## PLE library (data structure)

Informetis Co.,Ltd.

## **Note** (change list from original one)

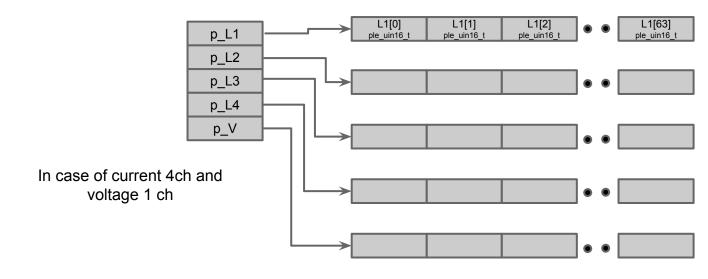
- Support variable channels
  - User can specify number of channels for both current and voltage.
- Minimize buffer size in the library
  - Size of work area is changed to for 1 second.
  - User has to pull encoded data right after input data of 1 second.
  - In case of encoding data for 100 seconds, if error has occurred in 90 seconds, user has to quit entire encoding process because there is inconsistency between parameter in PLC header which indicate number of encoded seconds and real length of encoded data.
     In this case, sensor should complete communication to server with error.
